2-4 Doughty Mews, London, WC1N 2PG -
2023/2928/P

Delegated Report Member's Briefing		Analysis sheet		Expiry Date: 11/09/2023	
		N/A		Consultation Expiry Date: 28/09/2023	
Officer			Application Number(s)		
Ewan Campbell			2023/2928/P		
Application Address			Drawing Numbers		
2-4 Doughty Mews, London WC1N 2PG			Please refer to draft decision notice		
PO 3/4	Area Team Signature	C&UD	Authorised Officer Signature		
Proposal(s)					
Erection of roof extension and front roof terraces for both the Egypt Exploration Society building and residential apartment. Alterations to fenestration on ground and first floor including new window and door openings, new cycle stores and air vents and air source heat pumps					
Recommendation(s):		Grant condition planning permission subject to s106 agreement			
Application Type:		Full Planning Permission			
Conditions or Reasons for Refusal:		Refer to Draft Decision Notice			
Informatives:					
Consultations					
		No. of responses	31	No. of objections	27

DECISION
Erection of roof extension and front roof terraces for both the Egypt Exploration Society building and residential apartment. Alterations to fenestrations on ground and first floor including ne

Plans and Elevations (existing on the left and proposed on the right)

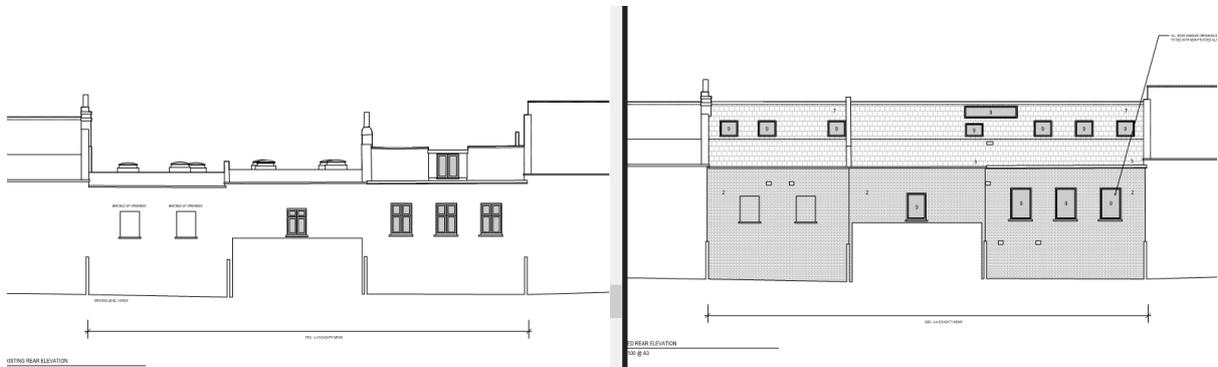
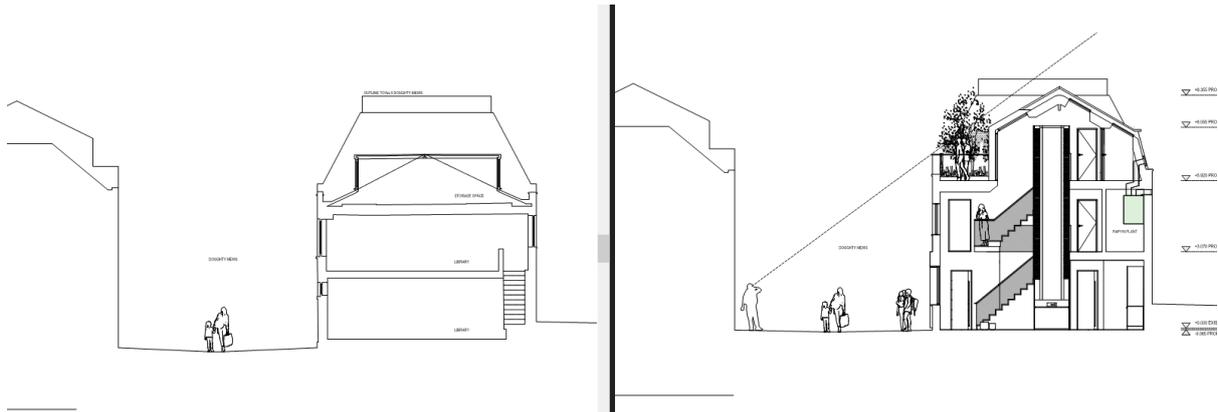
3.9 The roof extension and terrace would extend across the three buildings and would include a front

dormer or atrium style element to the front. The extension is sufficiently set back by 3.0m as not to appear overbearing and appears comfortable in terms of the proportions of the building. The dual pitch roof design breaks down the scale further and means the overall extension still reads as subservient to the host buildings.

- 3.11 The material palette is considered acceptable, cladding the extension in timber and mixing this with a more traditional slate tiled roof. The dormer also contains timber fins and tripled glazed windows and doors creating an appropriate mix of traditional yet contemporary materials which helps soften the impact of the roof extension. The flush solar panels are also welcome and contribute positively to this character. The details in relation to materials and solar panels will be secured via a condition.

- 3.14 The changes include increasing the size of windows, alterations to the doors, incorporating timber fins as well as the use of timber as cladding and the use of triple glazed windows. The revised ground floor is a high quality design positively reflecting the traditional character of the building in a contemporary way. The revised design of the ground floor achieves this successfully, providing different ground floor fenestration treatments and through the use of timber retains a softer character which provides a link to the traditional windows which are also timber. The, retention of downpipes, successfully ensures these are read as separate buildings and the continued use of stall risers along the three buildings ensures there is an acceptable level of glazing on the ground floor. Overall the design is sympathetic to the prevailing character of the ground floor treatment in the mews but also is a subtle way of linking these buildings together.

- 3.21 As discussed above the proposed roof extension would add an additional floor and terrace to the front. The extension would increase the height of the buildings by a maximum of 3.6m from the existing roof line and have a pitched roof design angling away from the both Doughty Street and the other side of Doughty Mews. To the rear are the gardens of 6-8 Doughty Street and the roof extension would increase the height of the buildings by 2.1m which is directly to the rear of these gardens. This has a relatively low impact on amenity considering the separation distance (which is approximately 14m) from the Doughty Street properties, its end of garden location and limited increase in height. In relation to outlook, enclosure there would not be any adverse impacts due to the distance away from properties on Doughty Street and limited increase in height. There are a number of new windows being proposed to the rear roof slope of the extension however these would be obscure glazed to ensure there would be no direct overlooking or loss of privacy to neighbouring occupiers.

Roof

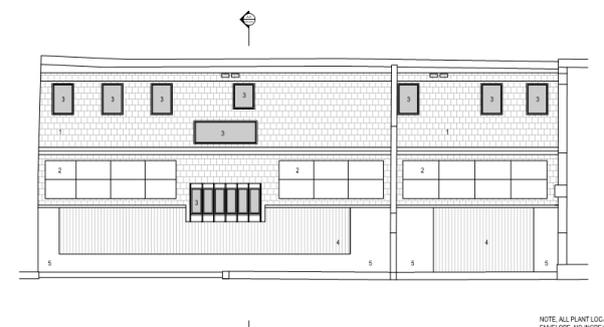
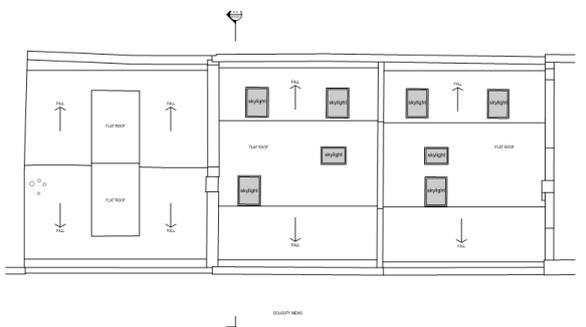
3.27 There are air source heat pumps (ASHPs), solar panels on the southern roof slope, mechanical ventilation heat recovery system (MVHR being proposed however following revisions these are now kept to completely within the confines of the building with only a vent coming out of the second floor. Therefore this is not considered to impact on noise for the neighbours along the mews on Doughty Street however a standard noise condition will be placed on the application to ensure the plant does not exceed these levels

- 11 The external noise level emitted from plant, machinery or equipment at the development hereby approved shall be lower than the typical existing background noise level by at least 10dBA, or by 15dBA where the source is tonal, as assessed according to BS4142:2014 at the nearest and/or most affected noise sensitive premises, with all machinery operating together at maximum capacity.
